Observations on the LB Merton's topic paper on the historic environment of Wi3.

Dr D.G. Dawson, for The Wimbledon Park Residents' Association, October 2022

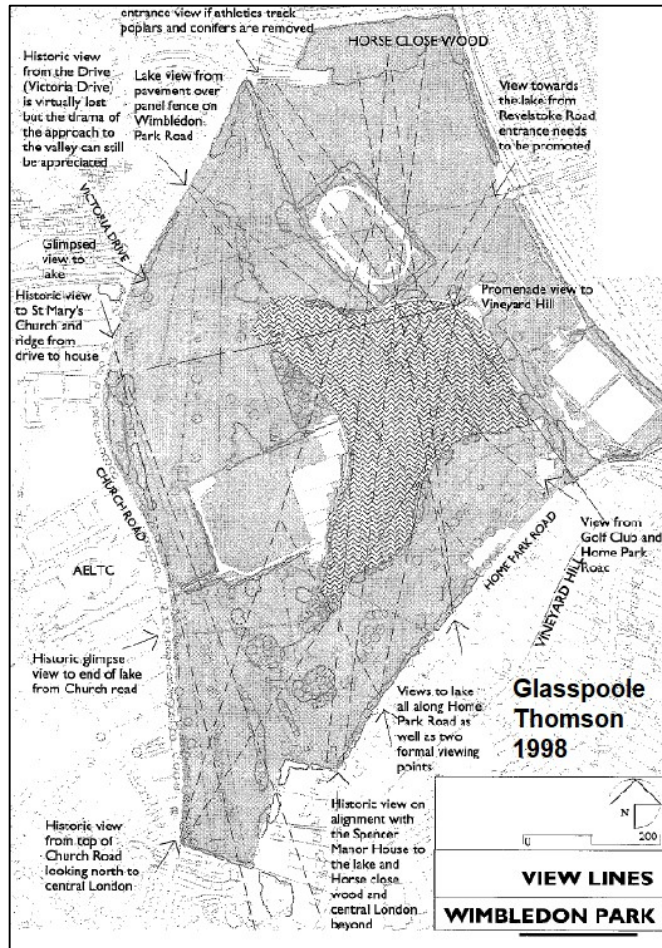
Many more actual views, both those designed by Brown, some of which are extant, and those coming about later, were described in the 1998 *Wimbledon Park Restoration Proposals*¹⁷ (reproduced above), and this was updated and corrected in 2016¹⁸. It is quite wrong to promote the few, truncated and partly erroneous views of the character assessment as a guide, so reference to the character assessment in the proposed modification should be deleted and replaced by reference to the 1998 analysis as updated and corrected.

Clearly, the guidance on views in the Topic paper is unreliable. It must be replaced by an authoritative source.
